NIOSH Response to SC&A Comments on

ORAUT-RPRT-0072

Response Paper

January 4, 2019

Figure 1. SRS Tritium Annual Doses

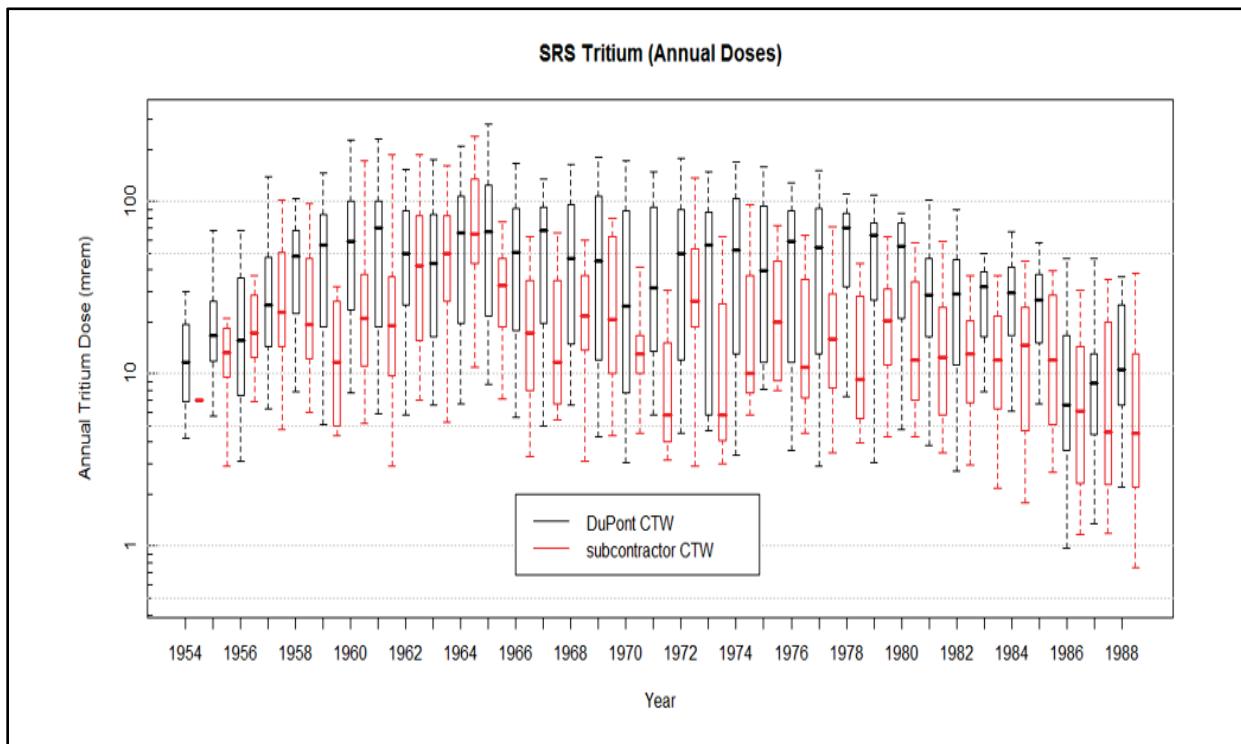
SC&A Specific Question 3: *In terms of potential operational sources of STCs, no discussion is provided for contamination during D&D activities, which were extensive during the 1990s (including the closure of the older tritium facilities). Given the engineering controls in place, the D&D phase would have been an operational phase with some vulnerability for SMT exposure.*

NIOSH Response: Co-worker intakes from tritium published in ORAUT-RPRT-0081, Section 4.2, cover all activities and are stratified between operations and trade workers, the latter being involved in D&D tasks (ORAUT 2017b). Construction trade workers (CTW) included both prime contractor and subcontractor workers.

Figure 1 shows a box plot of tritium dose statistics for prime versus subcontractor CTW. Median doses for subcontractor CTW are lower than the median dose for prime CTW in all years. The 95th percentile dose for prime CTW is higher than that of subcontractor CTW for all but three years.
